## SAFETY NOTICE

**SUBJECT: RISK OF ACCIDENTAL OPENING OF THE CHIN STRAP QUICK-RELEASE SYSTEM (PROCLIP) WHEN ADJUSTING THE CHIN CURTAIN ON CKX TITAN AND MISSION HELMETS.**

Communication	Reference No.	Subject	Issu Date
No. 1	#SN_032020_CKX	Accidental opening of the chin strap	Mai 13 <sup>th</sup> , 2020

#### SAFETY NOTICE REGARDING CKX TITAN AND MISSION HELMETS

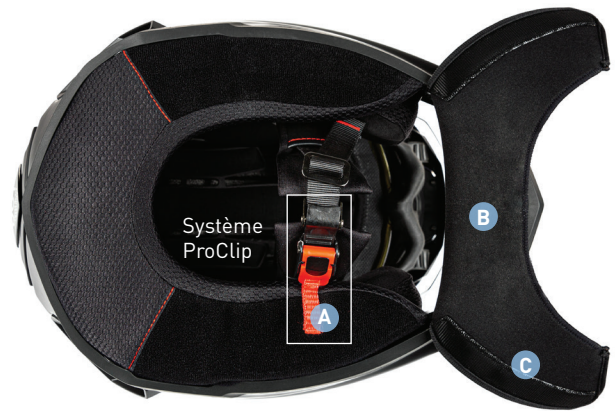
When adjusting the chin curtain **B**, the red fabric tab **A** of the quick-release system can be caught in the Velcro-type hook and loop fabric strip **C** and unintentionally be pulled out, thus loosening the chin strap of the helmet.

- A** Quick-release system red fabric tab
- B** Titan and Mission long chin curtain
- C** Velcro-type hook and loop fabric strip

Removing the long chin curtain allows the safe use of the helmet. This will prevent an inadvertent opening of the quick-release system, by preventing the red fabric tab from being caught in the long chin curtain Velcro part.
